Mr. Darren Westmacott Clerk of the Local Review Body The Moray Council 25 February 2015

I refer to the Neighbour Notification dated 12<sup>th</sup> September 2014 for planning application 14/01773/APP: erection of a dwelling house and associated works at the site South East of Orchard House, Spey Street, Garmouth by Mr. Cvril Smith.

## Objection to 14/01773/APP. N Sanderson

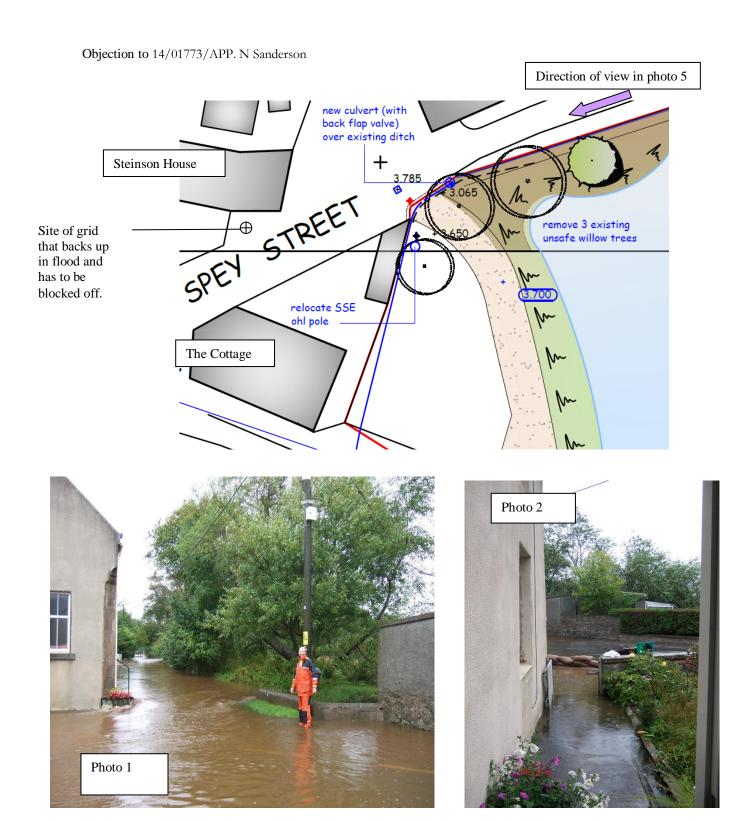
A major risk to my property is the street drain that enters the burn below the low concrete retaining wall (see photographs) and beneath the proposed access to the development. In times of flood this drain backs up and water emerges from the grids on my side of the street. This is the source of the water shown behind the sandbags in the attached photo "Entrance to Steinson House looking East Sept 2009" (Photo 2).

The applicant proposes a culvert with a flap valve to prevent backflow. As photographs 3 & 4 show, this culvert would cover the two existing drains and they would, presumably, have to be connected to it. The flap valve would be downstream of the problem drain. The combination of culvert and valve can only increase the hydrostatic pressure in the drain exit and further exacerbate the problem.

Photo 1 shows the height of water at the site of the entrance to the proposed property and the strong flow around the low wall from the ditch. A 600mm pipe would carry even less water than the existing open ditch and could increase the depth of water upstream of the culvert entrance, increasing the flood risk to The Cottage.

To install a drive through the existing banking, willow trees and retaining wall will allow flood water to flow more freely off the field and onto the road. (photos 1 & 5).

## Supplement 24/02/2015

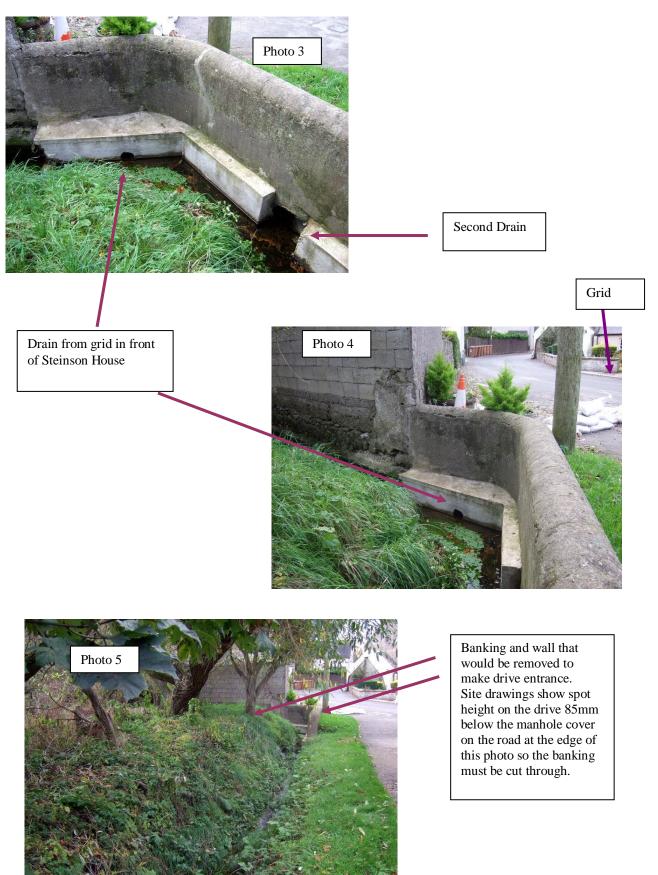
I have attached on the next page amendments to the Grampian flooding survey so kindly provided by Mr Smith.. The map on this page is the 2012 Ordnance Survey.

I have added the approximate positions of the present river banks and highlighted the area of woodland that has been lost. I have also corrected the direction of flow of water shown alongside the village hall.

As you can see, flood waters south of the viaduct had to flow through a woodland that was over 100m wide and about 300m long before reaching the fields around Ross House (Queen's Haugh). The trees would have slowed the flow considerably, so the flow rates given in the Grampian survey will be serious underestimates now that the river flows directly onto the fields.
